# SERVICE BULLETIN

**Service Bulletin No.:** DAC1-11-01 Rev 3

**Title:** Chinese Placards and Markings

Figure 1 (Sheet 1) - Aircraft Placards

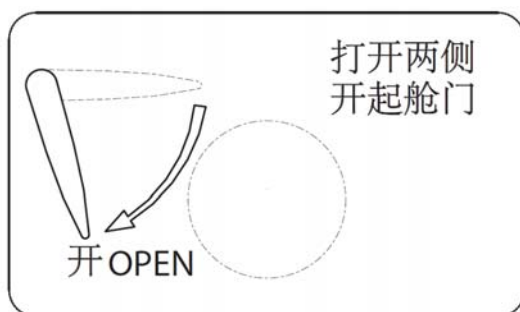
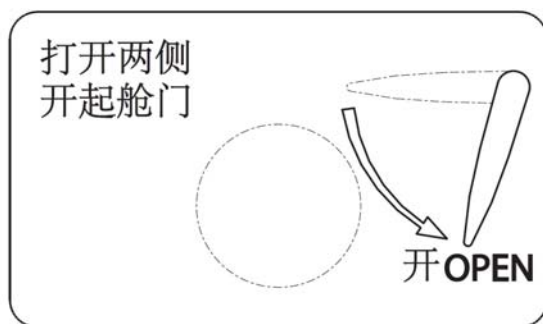
10.1 Replace the English language placards with the Chinese language placards as shown in Figures 1 and 2.

10.5.1 Refer to Figures 1 and 2 to identify the plastic foil placards and the location of each placard.

10.2 Replace the canopy lock position placard (P/N 22-1120-05-01).

10.3 Replace the exterior canopy latching placards (P/Ns 22-1120-05-19 and 22-1120-05-20)

Figure 2 (Sheet 2) - Aircraft Placards – Locations

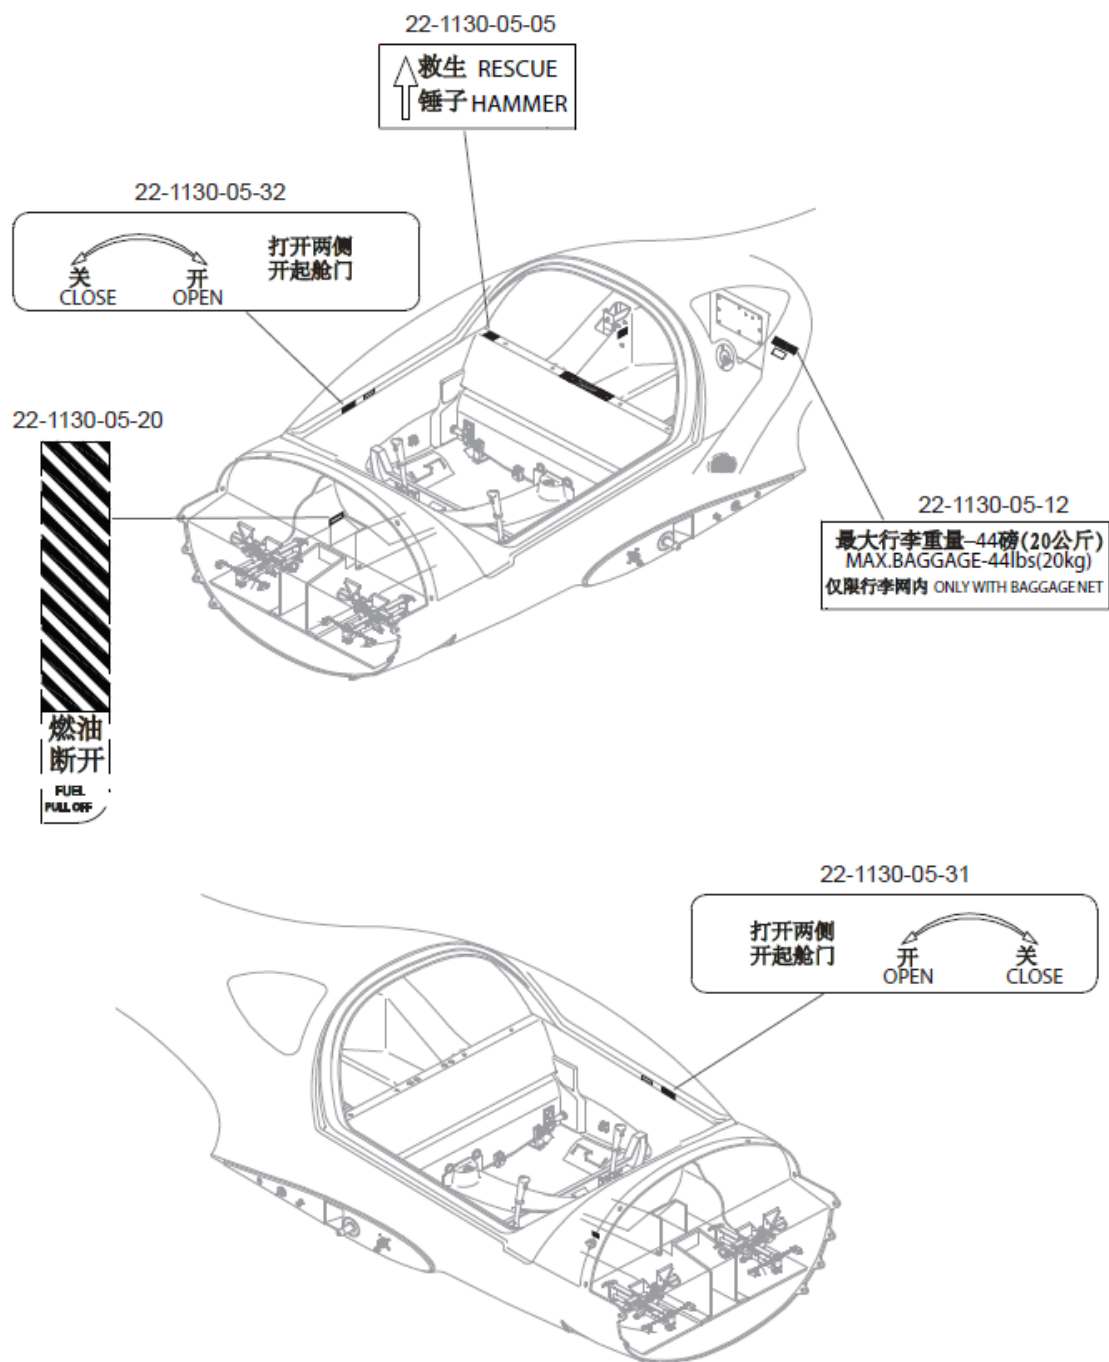
- 1. ATA Code:** 1120, 1130
- 2. Effectivity:** All DA20-C1 Aircraft for operation under Chinese registry.
- 3. General:** This Service Bulletin introduces the Chinese Placards and Markings and describes modifications required for aircraft operating under Chinese registry. Revision 1 of this Service Bulletin changes the compliance. Revision 2 of this Service Bulletin adds spinning allowance. Revision 3 of this Service Bulletin corrects parts numbers in Figure 2 (Sheet 2).
